SUBDIVISION COMMITTEE  
METROPOLITAN AREA PLANNING COMMISSION

STAFF REPORT  
(Preliminary Plat)

- CASE NUMBER:** S/D 98-15 - YMCA SOUTH ADDITION
- OWNER/APPLICANT:** Builders, Inc., 1081 S. Glendale, Wichita, KS 67218
- SURVEYOR/ENGINEER:** Mid Kansas Engineering Consultants, Inc., 411 North Webb Road, Wichita, KS 67206

(Final Plat, Preliminary Plat approved 2/19/98)

DRAINAGE & UTILITY CONCEPT

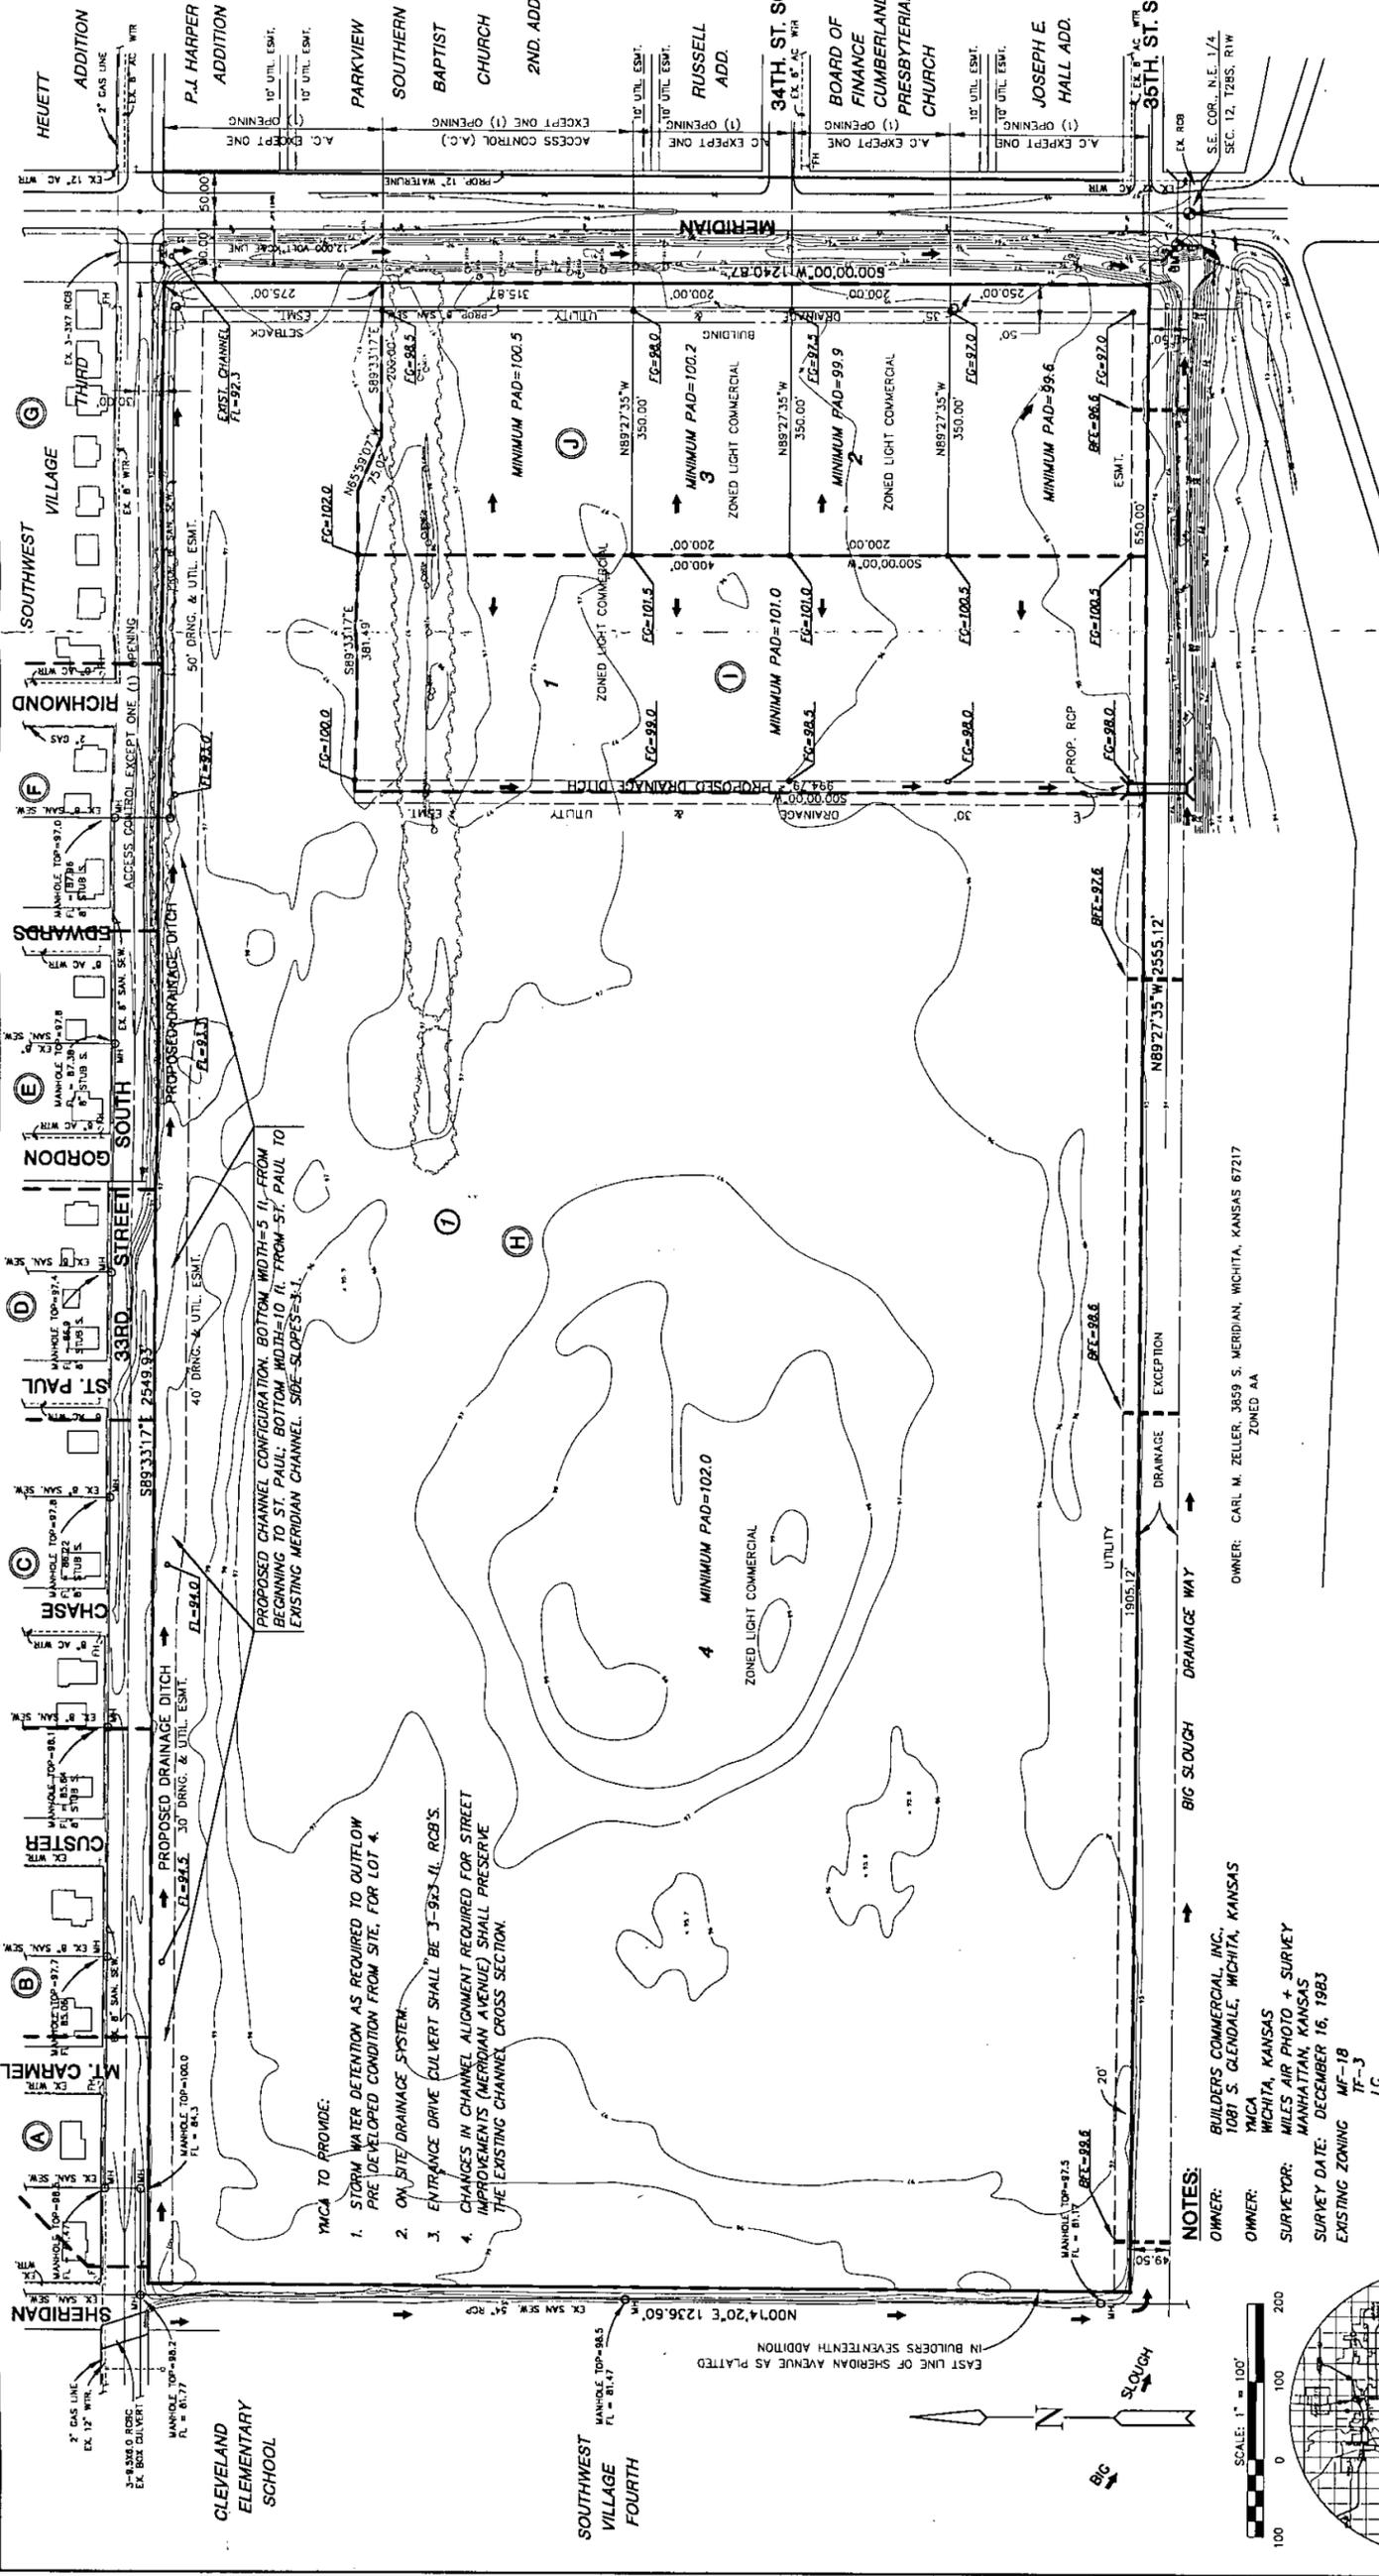
- C. **City Engineering** needs to comment on the status of the applicant's drainage concept.
- D. The plat does not conform with the access controls approved for the CUP. The plat denotes five openings along Meridian; whereas the CUP restricted the site to four openings. The CUP also required a joint access between lots 1 and 2. The joint access easement will need to be established by separate instrument. Initial construction responsibilities and future maintenance of the driveway within the easement should also be addressed by the text of the instrument.

- C. **City Engineering** needs to comment on the status of the applicant's drainage concept. **The drainage concept is approved. A guarantee will need to be submitted for drainage improvements.**

- YMCA TO PROVIDE:
1. STORM WATER DETENTION AS REQUIRED TO OUTFLOW PRE DEVELOPED CONDITION FROM SITE. FOR LOT 4.
  2. ON SITE DRAINAGE SYSTEM.
  3. ENTRANCE DRIVE CULVERT SHALL BE 3'-9 1/2" I.L. R.C.B.'S.
  4. CHANGES IN CHANNEL ALIGNMENT REQUIRED FOR STREET IMPROVEMENTS (MERIDIAN AVENUE) SHALL PRESERVE THE EXISTING CHANNEL CROSS SECTION.
